# UNITED STATES PATENT AND TRADEMARK OFFICE

APPLICATION NO.	FILING DATE	FIRST NAMED INVENTOR	ATTORNEY DOCKET NO.	CONFIRMATION NO.
10/530,077	09/22/2005	Marcos Giovanni Bortoli	04306/0202707-US0	7459
7278 7590 05/27/2010 DARBY & DARBY P.C. P.O. BOX 770 Church Street Station New York, NY 10008-0770				
EXAMINER KASTURE, DNYANESH G				
ART UNIT		PAPER NUMBER		
3746				
MAIL DATE		DELIVERY MODE		
05/27/2010		PAPER

### Office Action Summary

## **DETAILED ACTION**

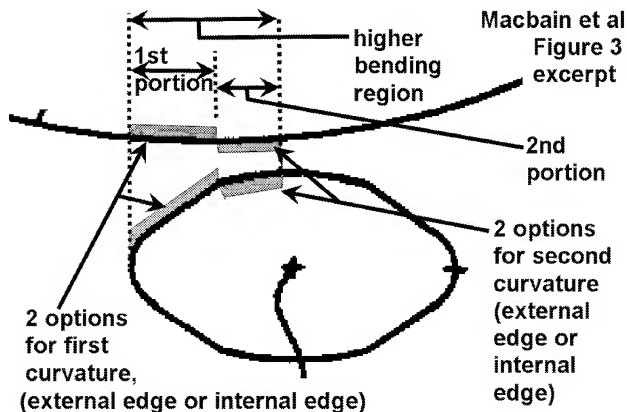
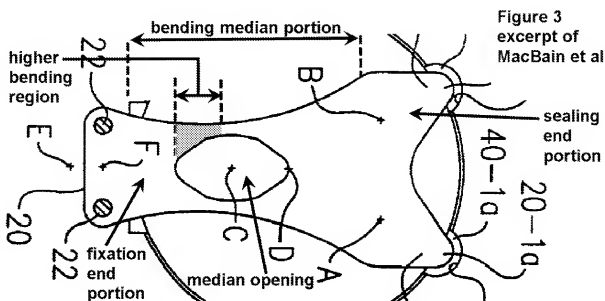
10. In Re Claim 1, with reference to Figure 3 annotated above, MacBain et al discloses a suction valve for a small hermetic compressor (Abstract states "compressor suction valve") of the type presenting a compression cylinder (D) which has an end closed by valve plate (30), said valve comprising:

- a fixation end portion (annotated) to be affixed to the valve plate;
- a bending median portion (annotated) provided with a median opening (annotated) aligned with a discharge orifice (see Figure 1); and

- a sealing end portion (annotated) operatively associated with the suction orifice provided in the valve plate,
- a higher bending region (as annotated by the shaded area, the width of which decreases along the higher bending region) of the flexible vane of the valve

- a first portion of the higher bending region as depicted above, bounded by at least one curved edge (first curvature) represented by the external edge of the flexible vane; (the shaded rectangles in the annotated first and second portions above highlight the options for the first and second curvatures)

- a second portion of the higher bending region as depicted above, bounded by the curved external edge and curved internal edge (second curvature)
- wherein the distance between an external edge of the flexible vane and its adjacent internal edge portion of the median opening diminishes more "intensely" in a first portion as implied by the steep decline in the first portion as compared to the gradual decline in the second portion; from a maximum value close to the end fixation portion, to a minimum value, close to the boundary of the higher bending region of the

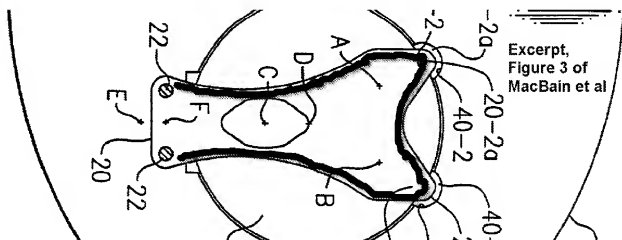
- wherein the flexible vane is configured to distribute opening forces along the higher bending region (no areas of stress concentration) allowing the flexible vane to be bent along the higher bending region in an open position, and
- the bending median portion and sealing end portion "presents" a U shape as annotated below, with the legs being symmetrical about a longitudinal axis of the flexible vane, are of equal length and are united by the fixation end portion as depicted:

(Note that the limitation "presenting" could also be broadly interpreted as enclosing a U shape, since the outline is not being claimed as U shaped. Further, the "united by" limitation could be interpreted as bringing the two legs together.)

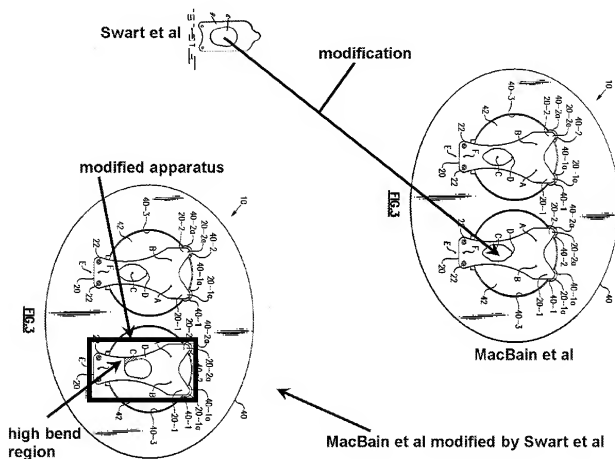
18. Alternatively, in addition to MacBain et al as applied to claim 1 above, it would have been obvious to a person having ordinary skill in the art at the time of the invention to substitute the hole (opening) of MacBain et al with the hole (opening) of Swart et al because the modification yields predictable results since both valves relate to the suction side of reciprocating piston compressors. In the modification, the initial

curvature of the boundary (progressing from left to right) of the hole of Swart et al is responsible ("by way of") for the rapid initial diminishing of distance between an external edge and adjacent internal edge portion of the median opening. The initial curvature therefore reads on the first curvature as claimed. The boundary of the vane reads on the second curvature as claimed.

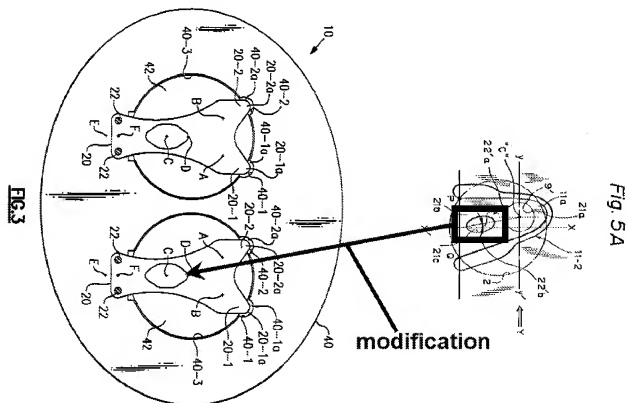
20. Alternatively, in addition to MacBain et al as applied to claim 1 above, it would have been obvious to a person having ordinary skill in the art at the time of the invention to substitute the hole (opening) of MacBain et al with the hole (elliptically shaped opening) of Swart et al because the modification yields predictable results since both valves relate to the suction side of reciprocating piston compressors. In the modification, the initial curvature of the boundary (progressing from left to right) of the hole of Ikeda et al is responsible ("by way of") for the rapid initial diminishing of distance between an external edge and adjacent internal edge portion of the median opening. The initial curvature therefore reads on the first curvature as claimed. The boundary of the vane reads on the second curvature as claimed.

**FIG. 2**

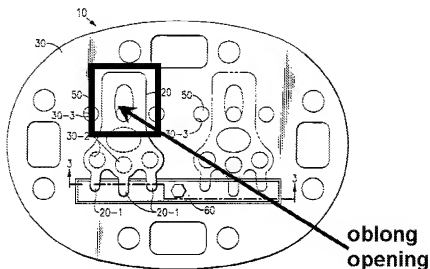
26. The prior art made of record and not relied upon is considered pertinent to applicant's disclosure. Fraser et al (US Patent 6,099,275 A) discloses another oblong shaped opening in a valve of Figure 2:
